North Dakota Department of Transportation

ADDENDUM 2 – JOB 43

TO: All prospective bidders on project SIM-8-029(136)053, Job No. 43 scheduled for the November 14, 2014 opening.

STATE	PROJECT NO.	SECTION NO.	SHEET NO.
ND	SIM-8-029(136)053	11	14

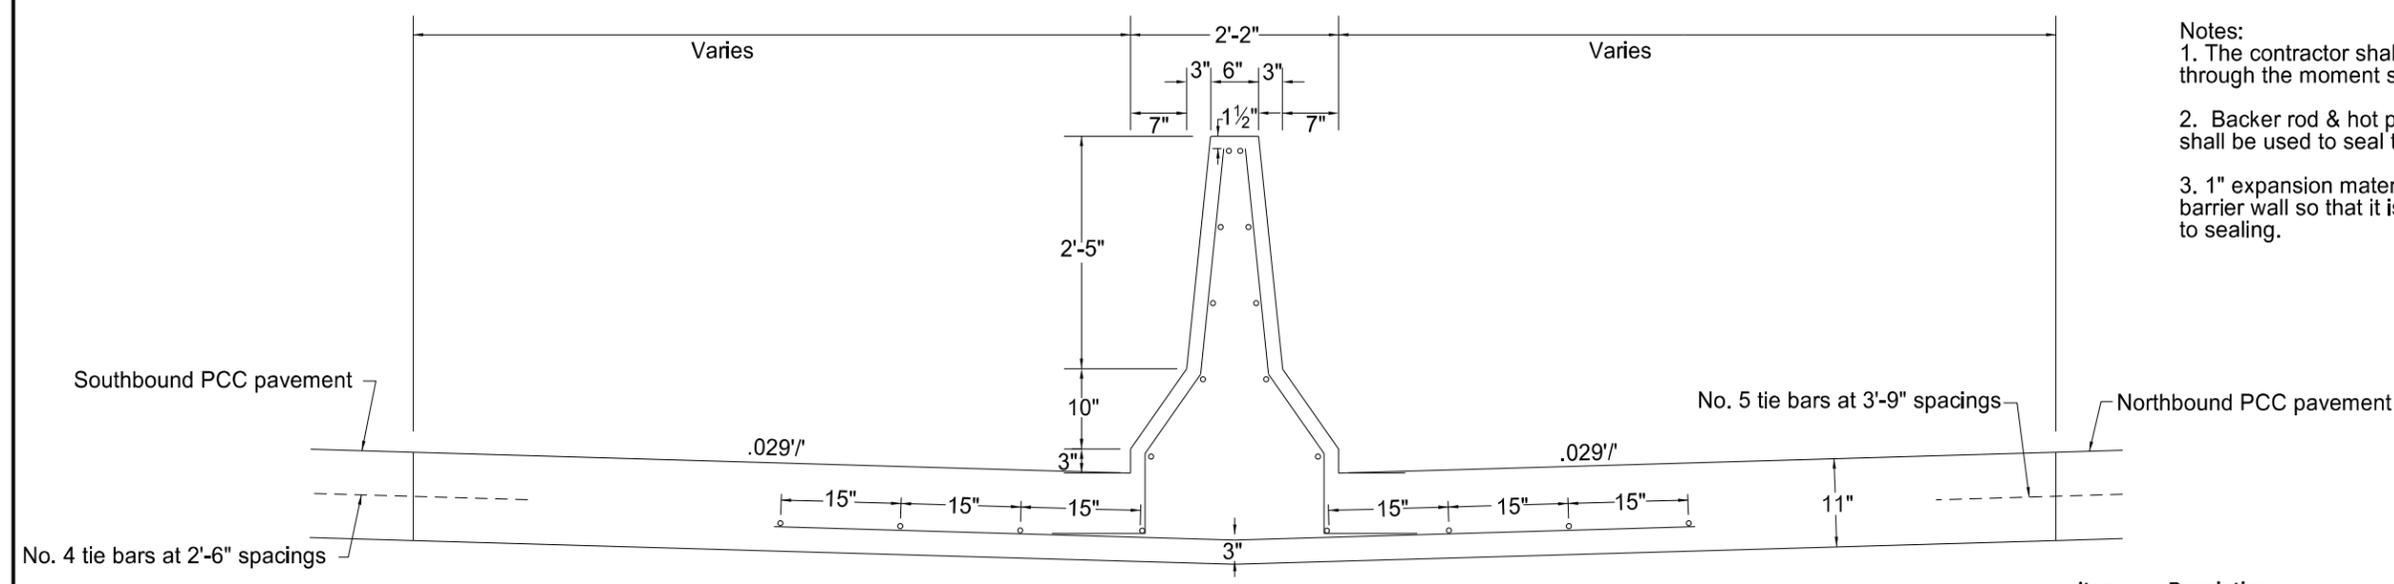
Sheet 11-14:

Added length and width dimensions to bridge deck spall repairs at RP 64.290 and RP 64.537.

Barrier Expansion Joint Detail
17th ave, Texas turn, 13th Ave, 9th ave

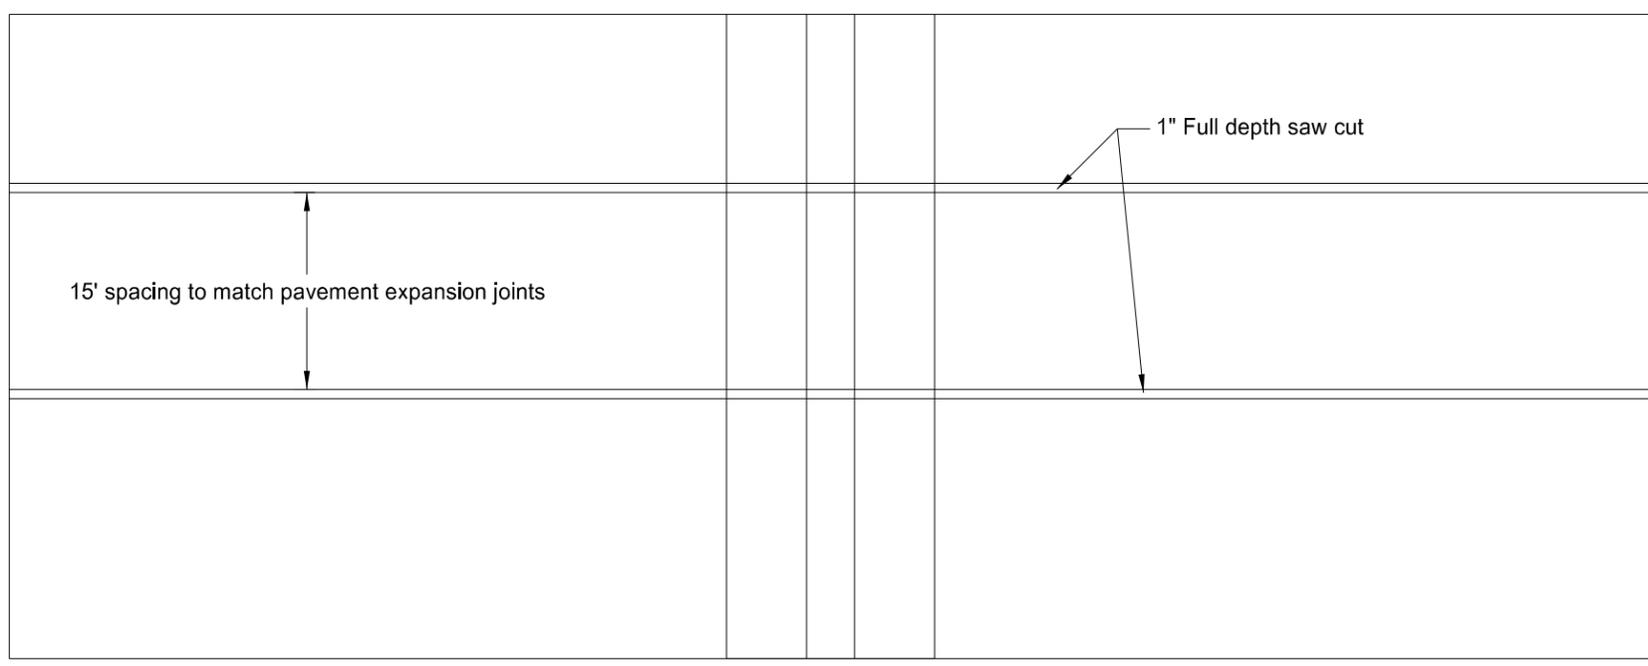
Sheet 20-8:

Added detail for expansion joint installation in median barrier.

STATE	PROJECT NO.	SECTION NO.	SHEET NO.
ND	SS-8-029(136)053	90	1

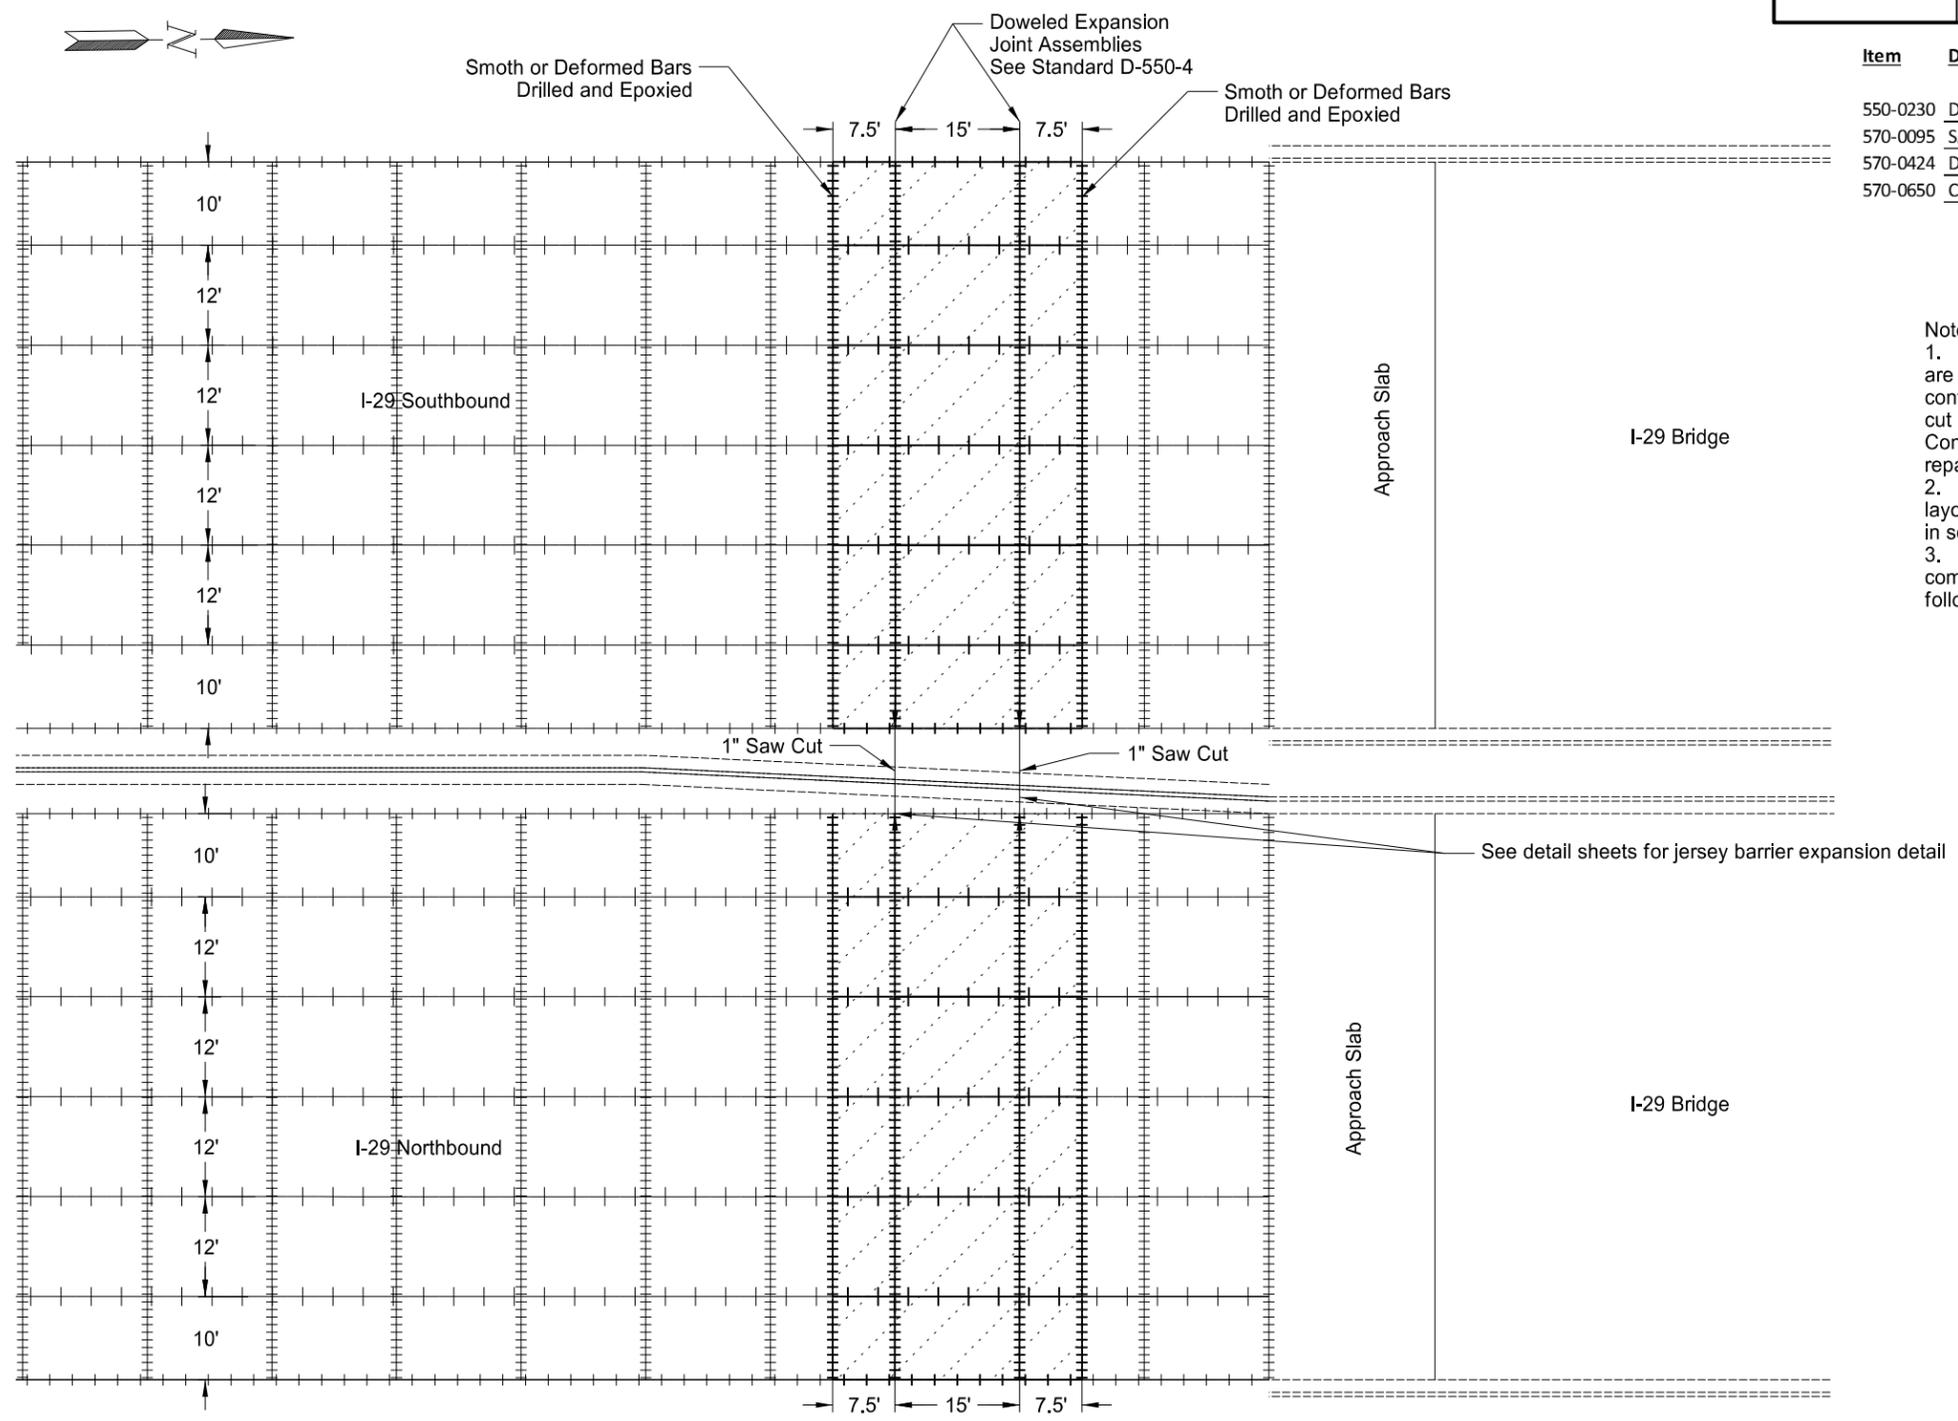
Sheet 90-1:

Added expansion joint layout sheet.

ATR Layout
 RP 55.5
 I-29

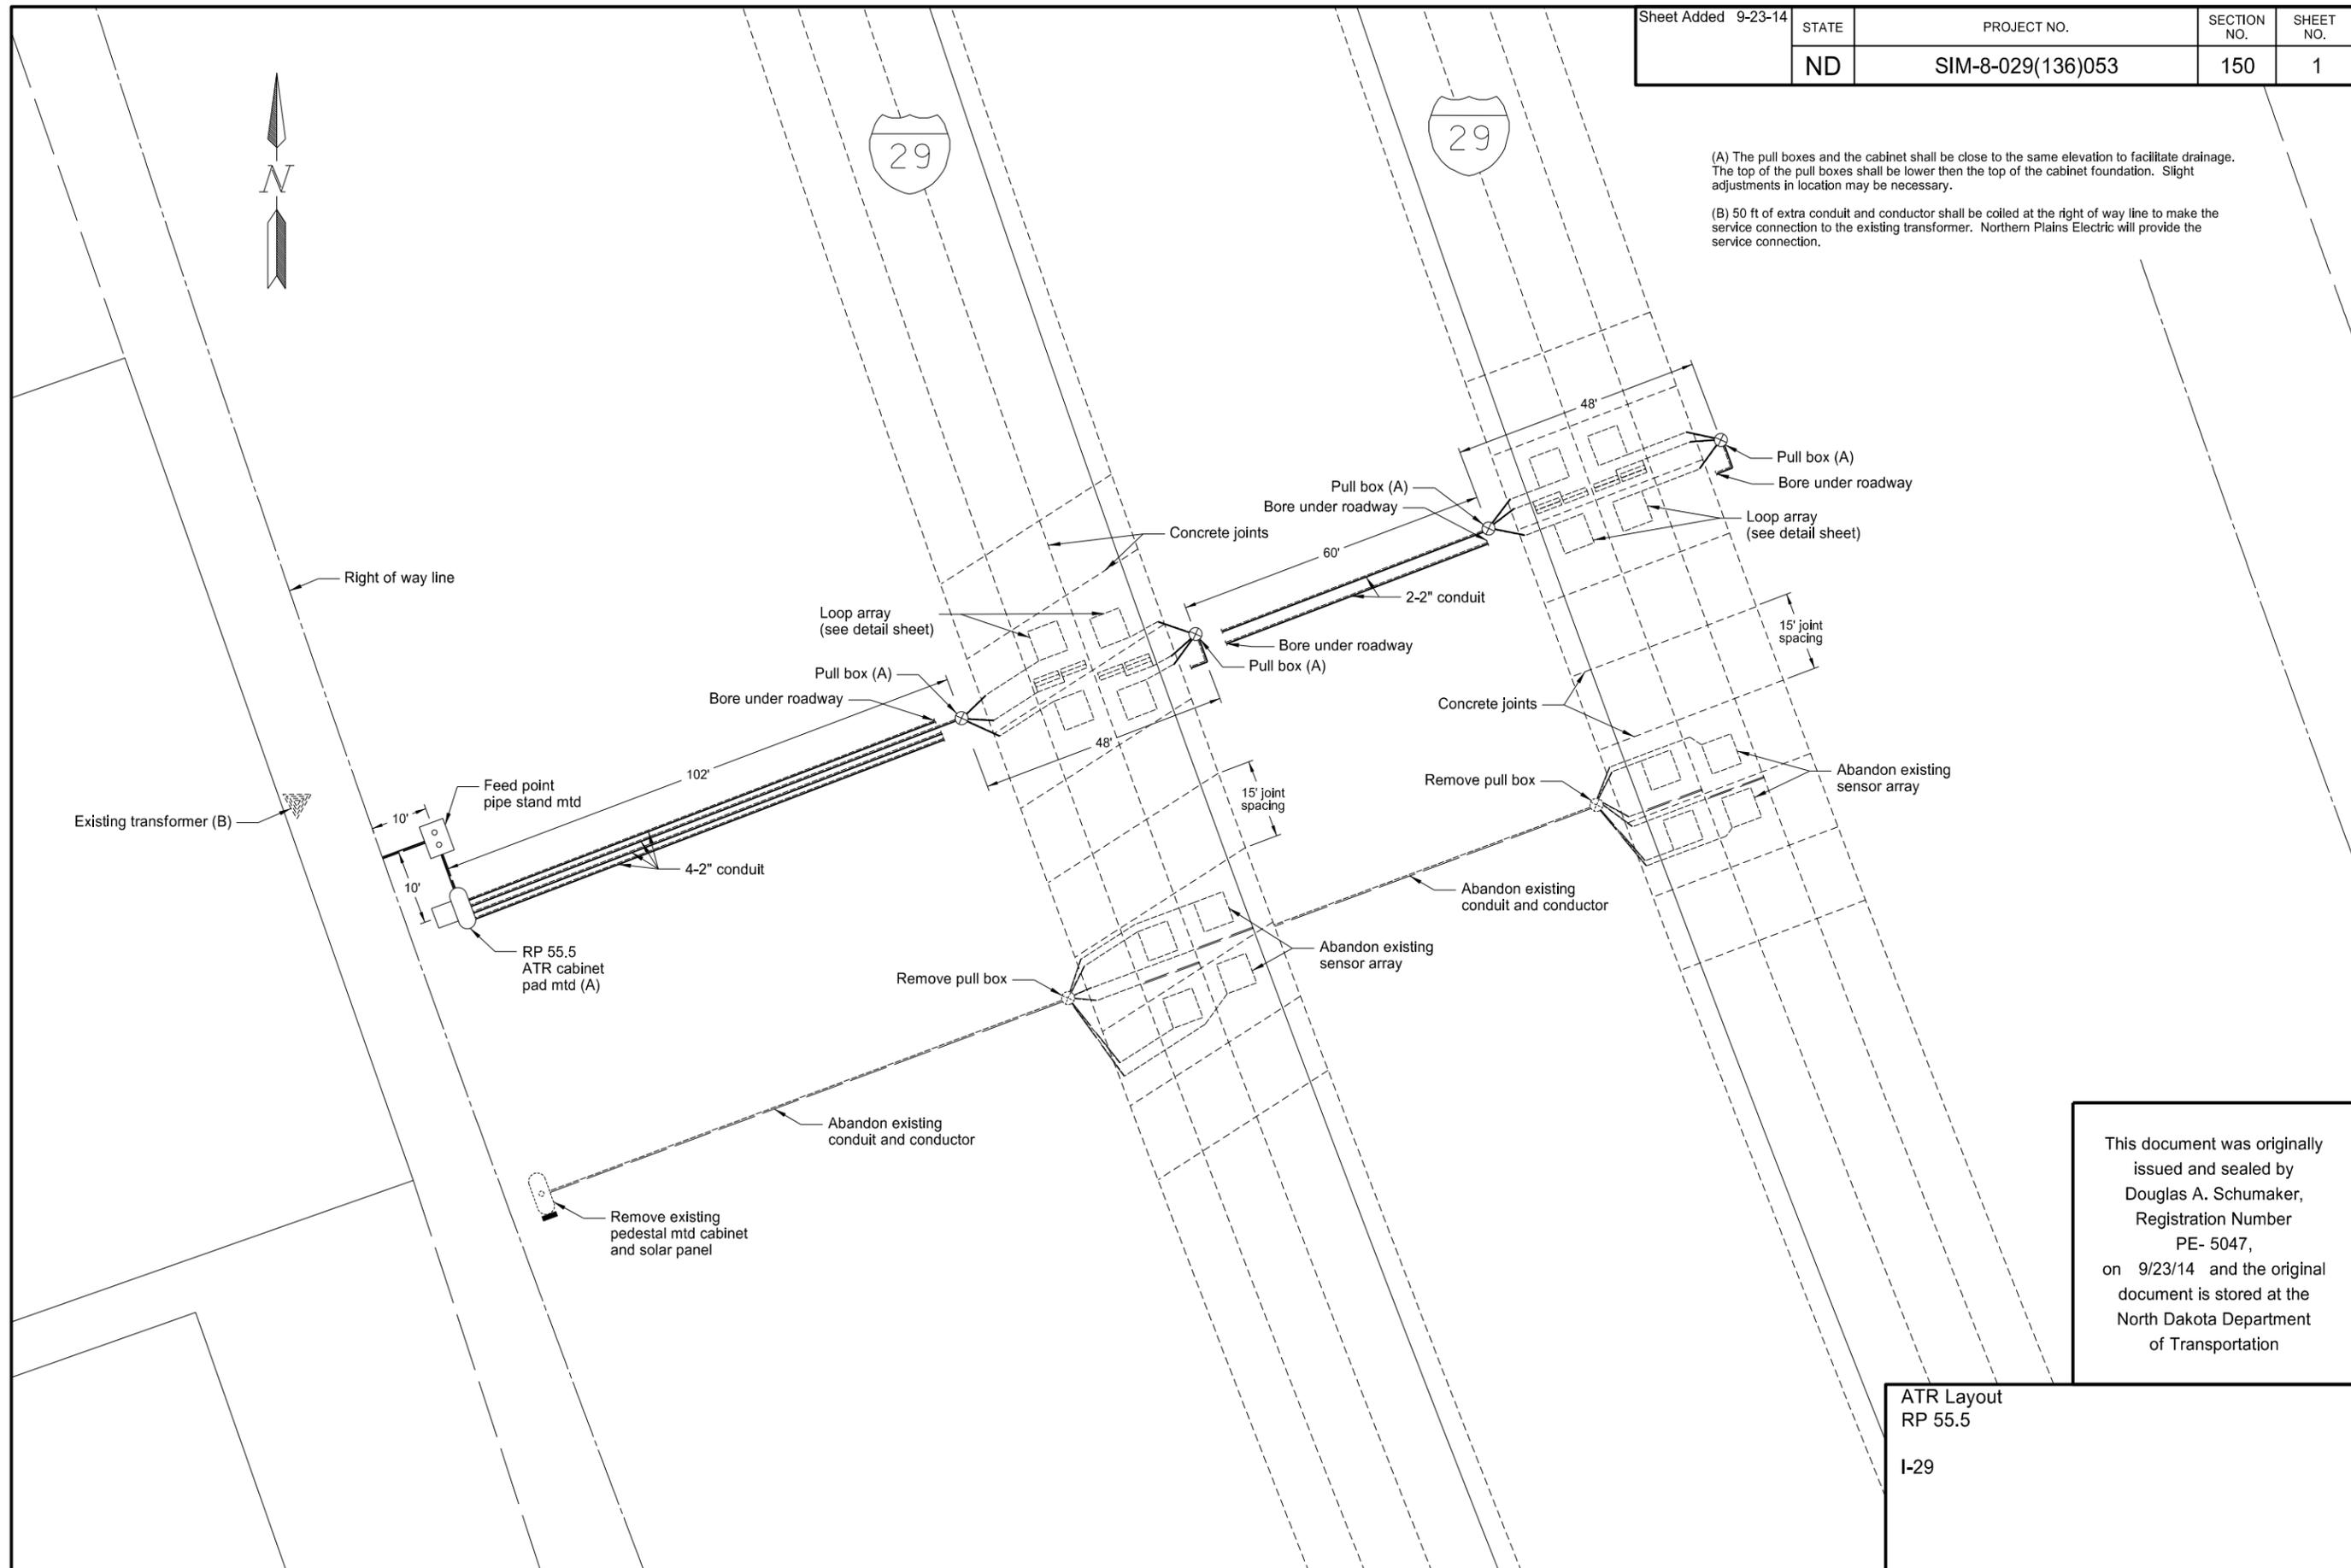
Sheet 150-1 to 150-4:

New ATR site details.
